# Access Compliance Report

## Public Rights-of-Way

### (Pedestrian Signals)

Intersection ID: N/A	Main Street:	Cross Street: N/A	Location: N/A
ADA ID: 73BC3A14A40D	Signal Type: One Push Button-APS	Overall Compliance: No	Severity Score: BTN 1: N/A BTN 2: N/A No BTN: N/A
Codes/Mitigation Info/Possible Solution		Field Measurements/Component Compliance

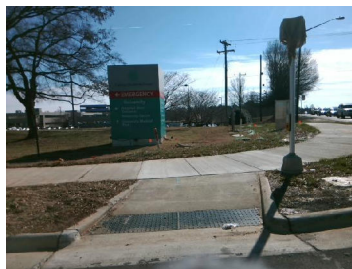
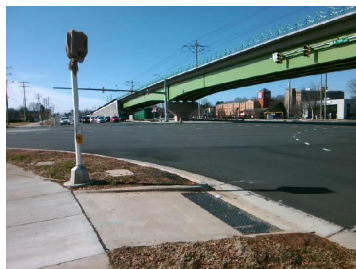
Surveyor Notes: NOT HOOKED UP, NOISES AND VERBAL COMMANDS UNKNOWN

PROW/ADA: TMUTCD 4e.08, R404.2, R404.3, R404.7.3, R404.7.2, R209.1, MUTCD 4e.10, R104.2, MUTCD 4e.08,

Possible Solutions: Replace Signal Push Button With APS Button on New Post. Remove & Relocate Sign.
